CANADA ENERGY REGULATOR

**TRANS MOUNTAIN PIPELINE ULC
APPLICATION FOR VARIANCE AND CONDITION RELIEF
UNDER THE CERTIFICATE**

December 14, 2023

**Re: Trans Mountain Pipeline ULC (Trans Mountain)
Trans Mountain Expansion Project (Project, TMEP)
Certificate OC-065
Mountain 3 HDD – Request for Variance
Response to Undertakings
CER File: OF-Fac-Oil-T260-2013-03 61**

In Line Design

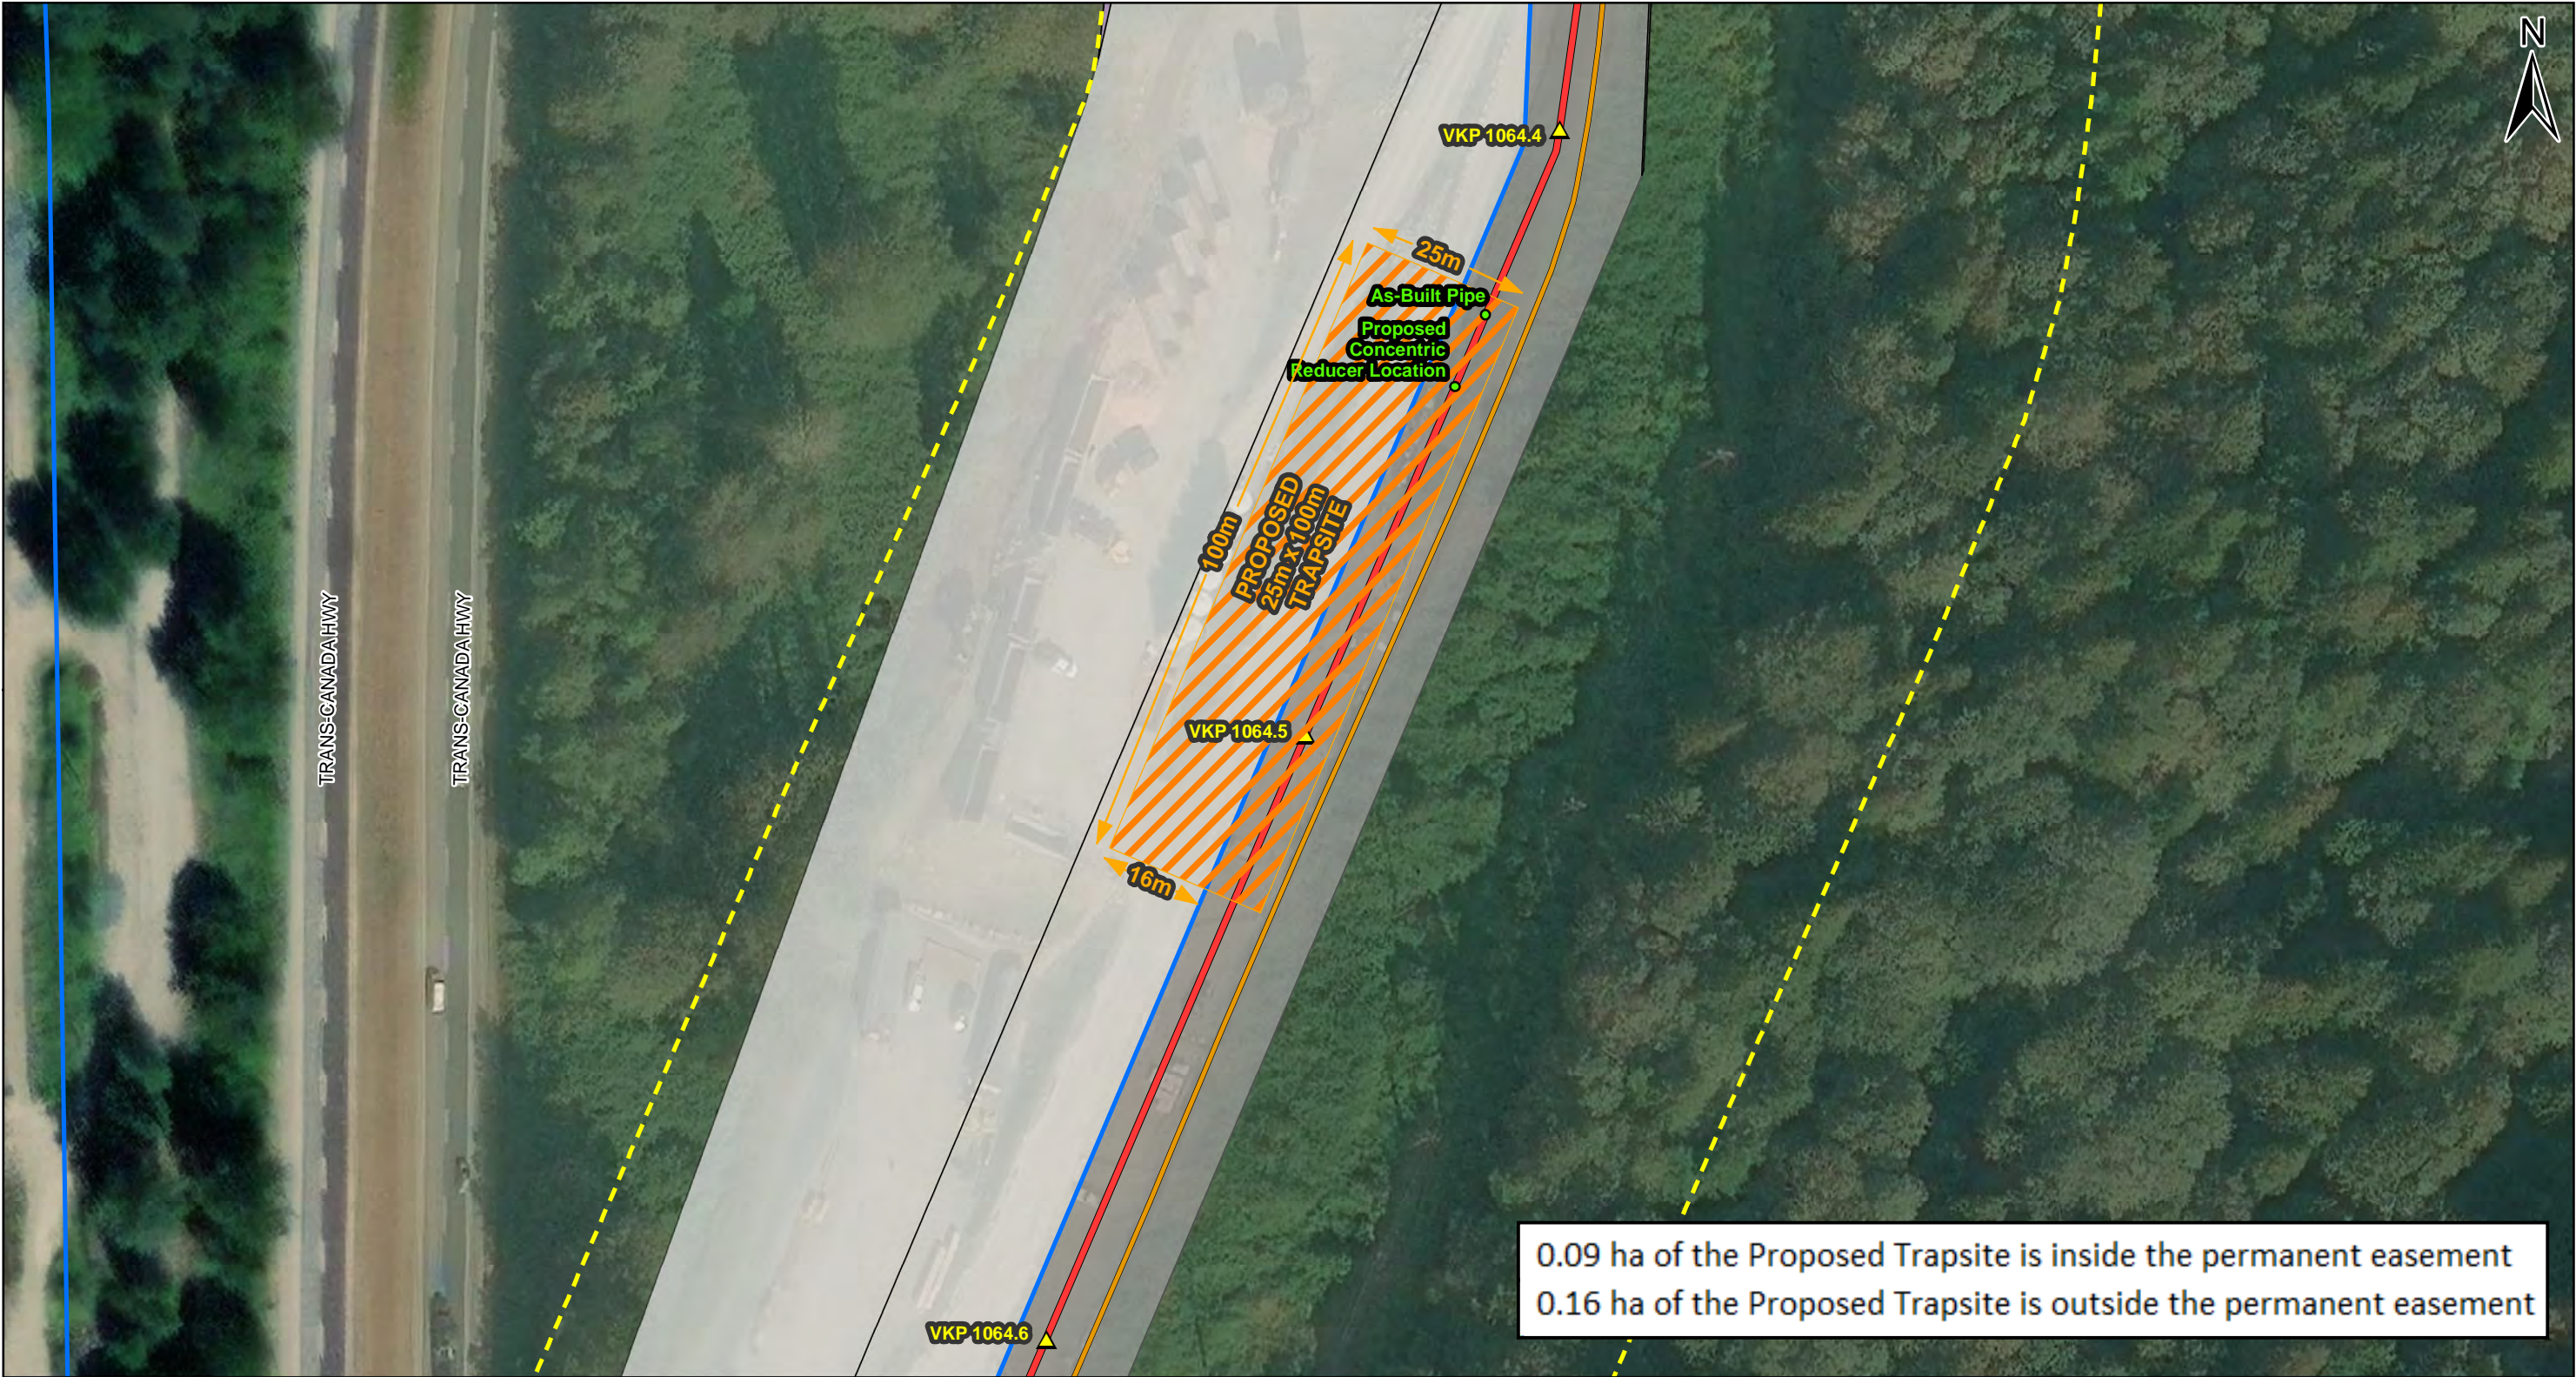
71. Additionally, as discussed in further detail below, the Variance will in no way impact Trans Mountain's ability to conduct ILI of the Mountain 3 HDD crossing. At the in-service date, Trans Mountain will have capability to inspect the entire length of the NPS 30 pipe for all threats, in compliance with Condition 143 of the Certificate.

TRANS MOUNTAIN EXPANSION PROJECT
DETAILED MAP
MOUNTAIN CROSSING 3 NORTH END

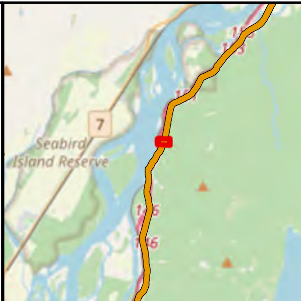
0.09 ha of the Proposed Trapsite is inside the permanent easement
0.16 ha of the Proposed Trapsite is outside the permanent easement

SCALE	ROUTE	DRAWING NUMBER	SHEET NO.	REV
1:1,000	5.24.19	M002-PM06606	1	3

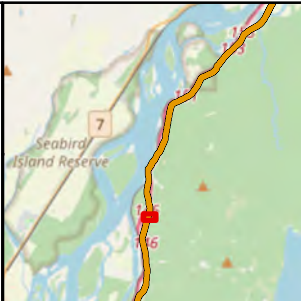
0.10 ha of the Proposed Trapsite is inside the permanent easement
0.15 ha of the Proposed Trapsite is outside the permanent easement
